MECKLENBURG COUNTY
DEPARTMENT OF ENVIRONMENTAL HEALTH

Application for an
Installation, Construction, Alteration, and/or Repair Permit
(Individual Septic Tank System with Subsurface, Soil Absorption, Effluent Discharge)

MECKLENBURG COUNTY
DEPARTMENT OF ENVIRONMENTAL HEALTH
INSTALLATION, CONSTUCTION, ALTERATION, AND/OR REPAIR PERMIT
(Individual Septic Tank System with Subsurface, Soil Absorption, Effluent Discharge)

CERTIFICATE OF APPROVAL

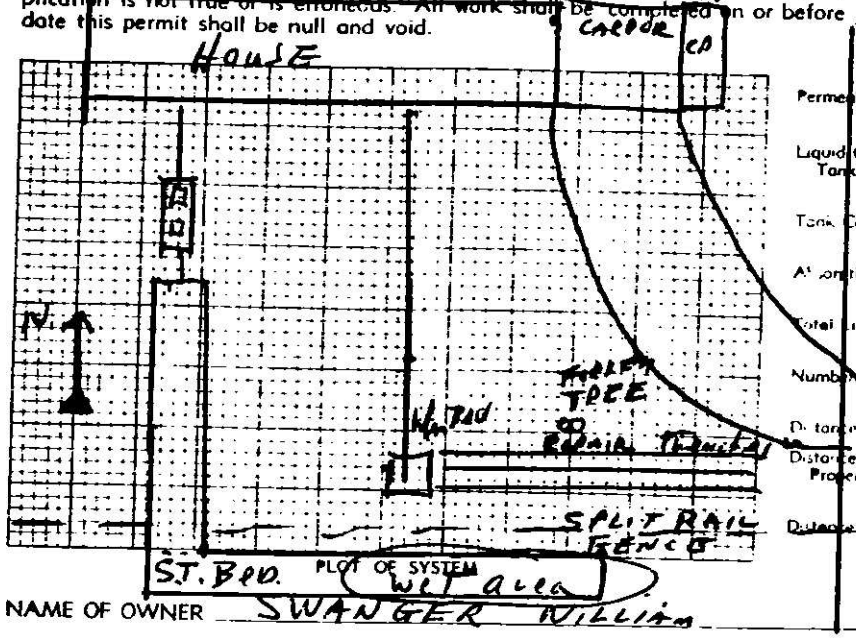
Comments: S.T. Drain Field to be covered with 6" Inches of Cecil Loam in Wet area W/in Repair to be three Trenches 24 FT x 3 FT x 12 inches Stone due to perked with Table Keep Trench 24 inches deep - Key at Stone Level
